BOARD OF COUNTY COMMISSIONERS ORANGE COUNTY, FLORIDA IFB NO. Y18-760-TA/ ADDENDUM NO. 1

PUMP STATION PACKAGE 18 IMPROVEMENTS

/ARD		OCU FILE NO.: 75687	SCALE: AS SHOWN
	DE	DESIGNED BY: SAB	DRAWING NO. :
		DRAWN BY: RAS	C301
	SCOTT A. BREITENSTEIN	CHECKED BY: SAB/DEM	0301
	PROFESSIONAL ENGINEER FLORIDA LICENSE #57402	CADD FILE: PS 3266 site plans	SHEET: 21 OF 60
			/

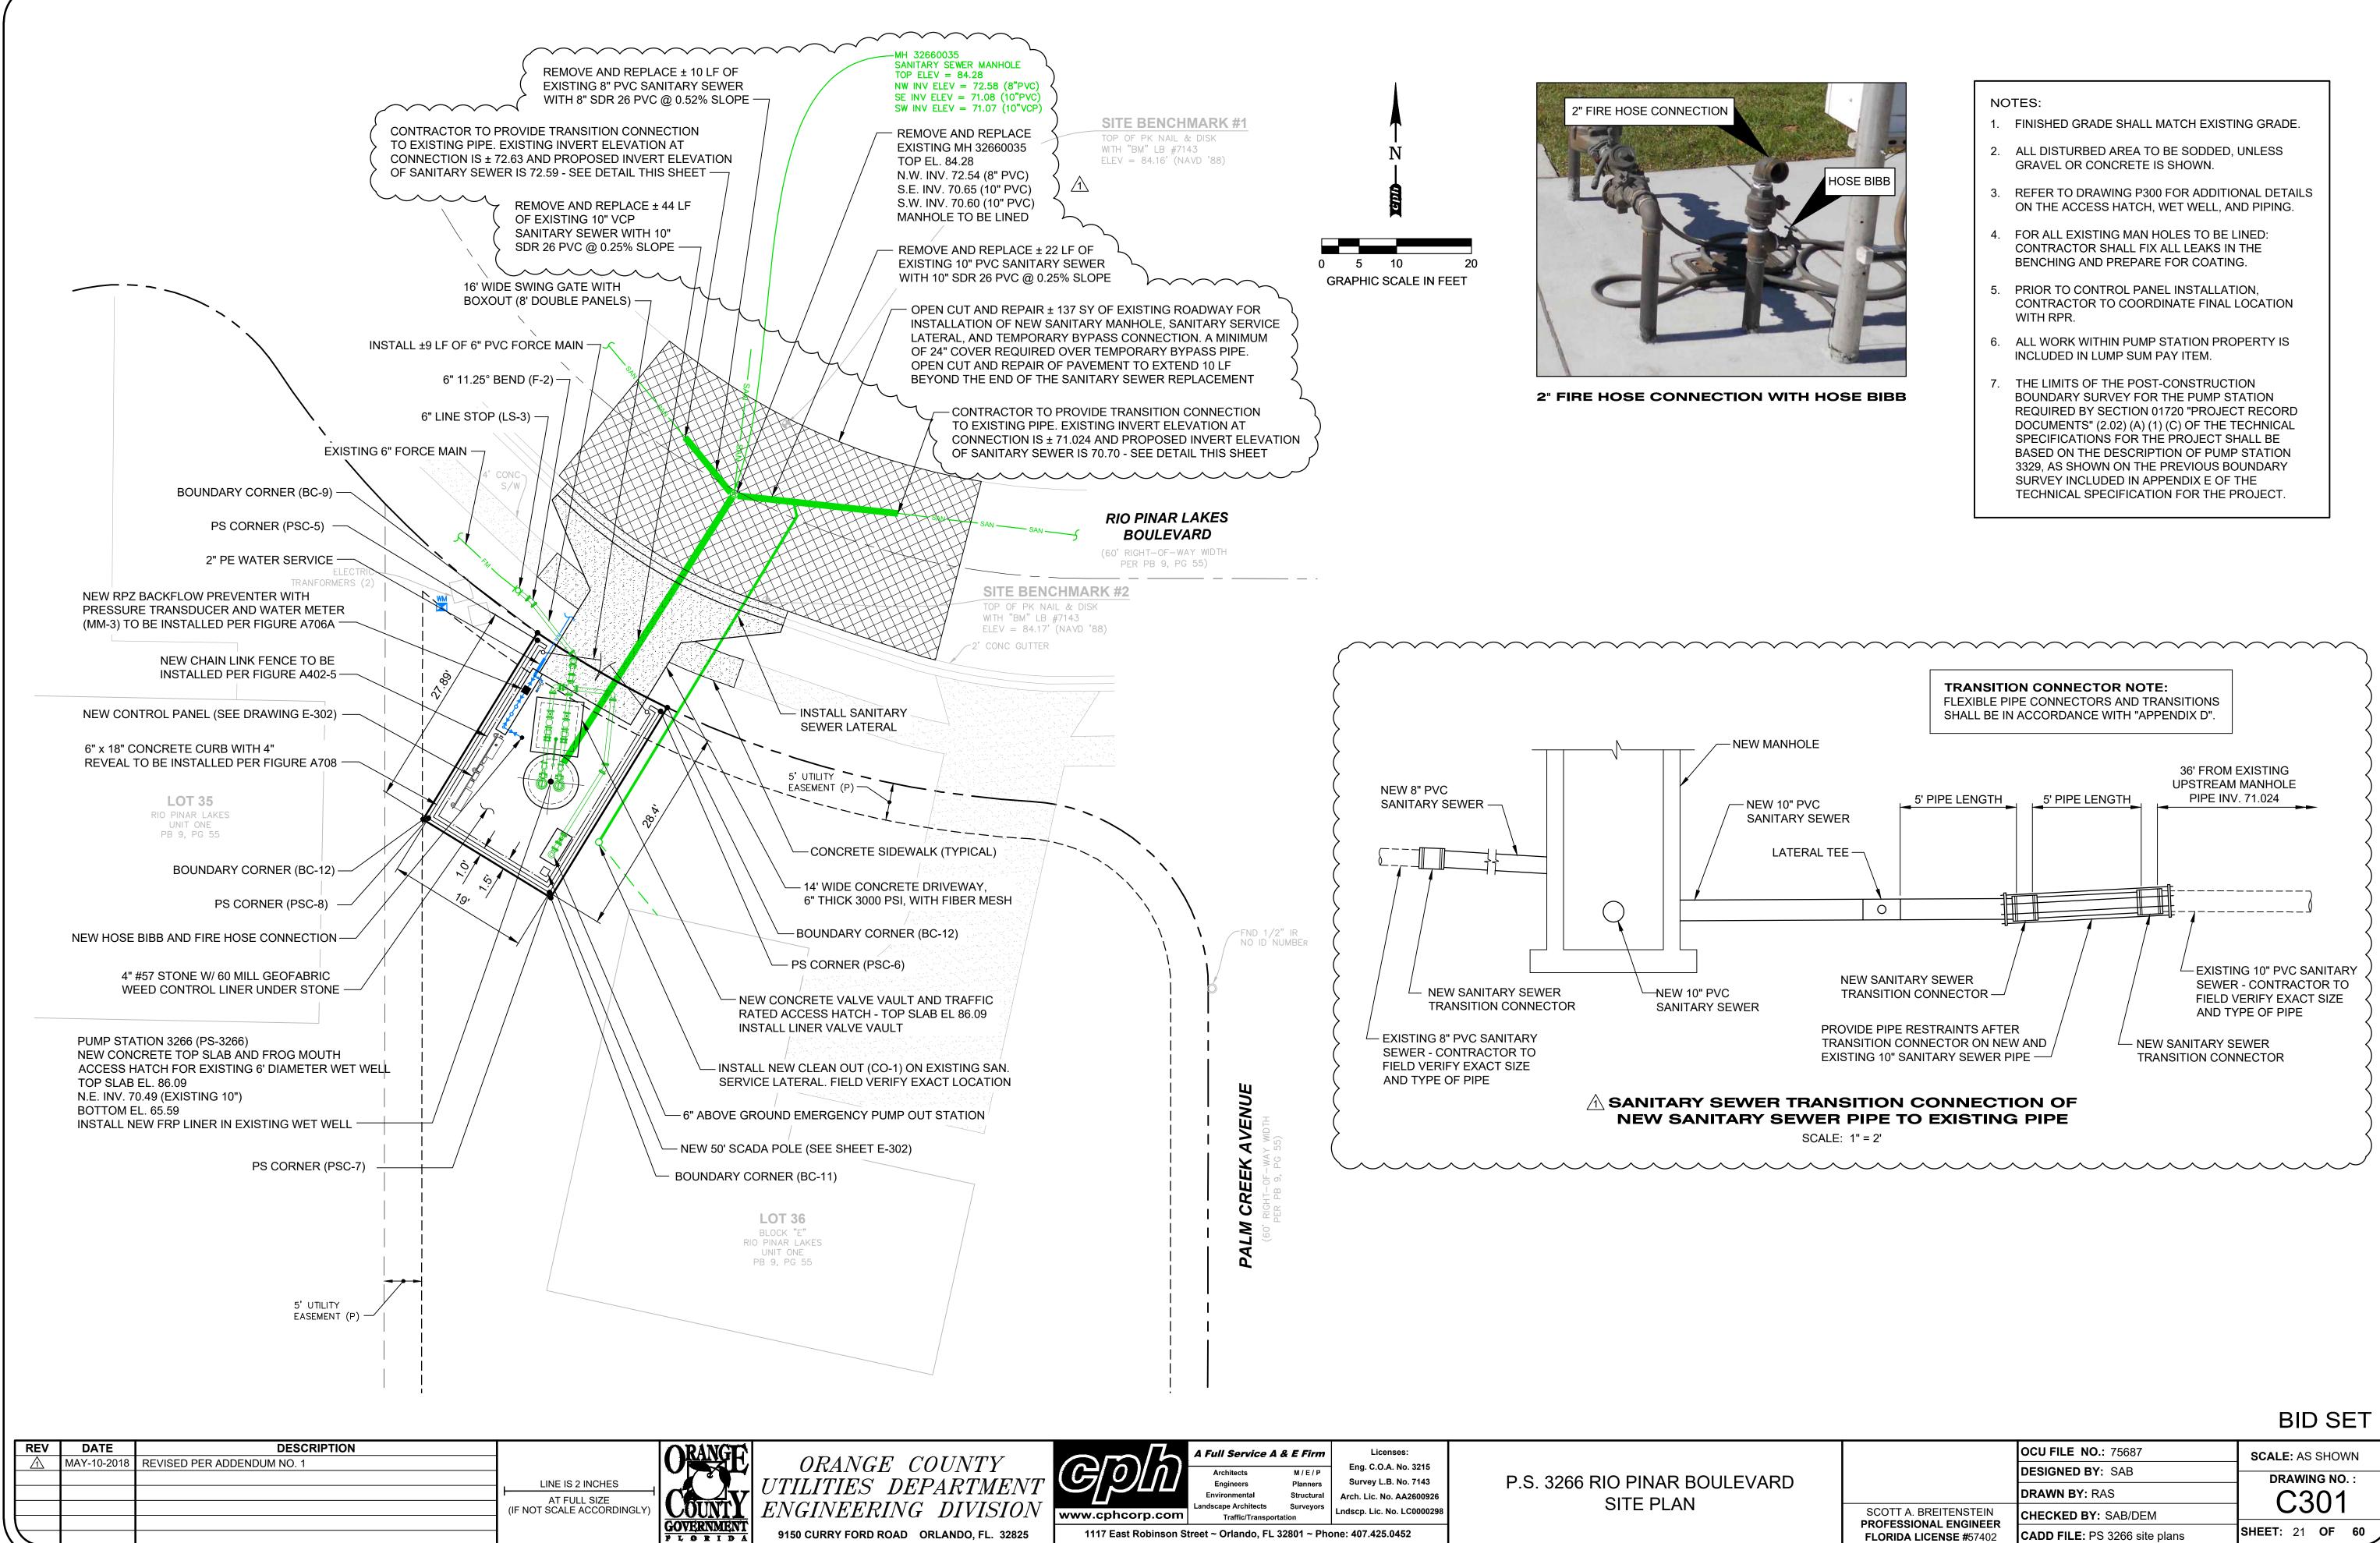
Delete sheet C301 and replace in its entirety revised sheet C301, attached to this addendum.
